| Notice of Allowability | Application No. | Applicant(s) |
| | 10/813,378 | VOGMAN, VIKTOR D. |

EXAMINER'S AMENDMENT

Examiners Amendment
Attachment To Paper #20060306

FIG. 5

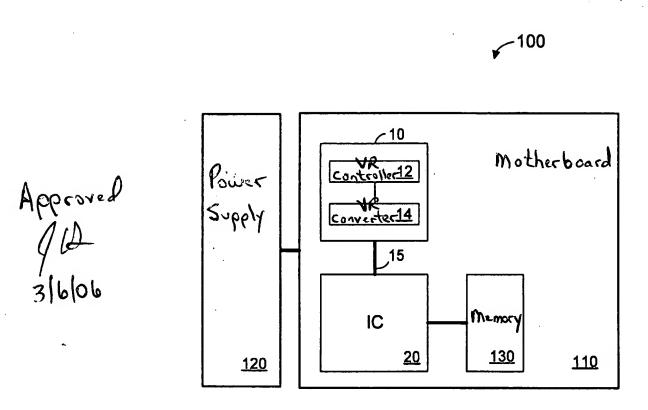
In The Drawings

Note attached copies of the drawings corrected in red.
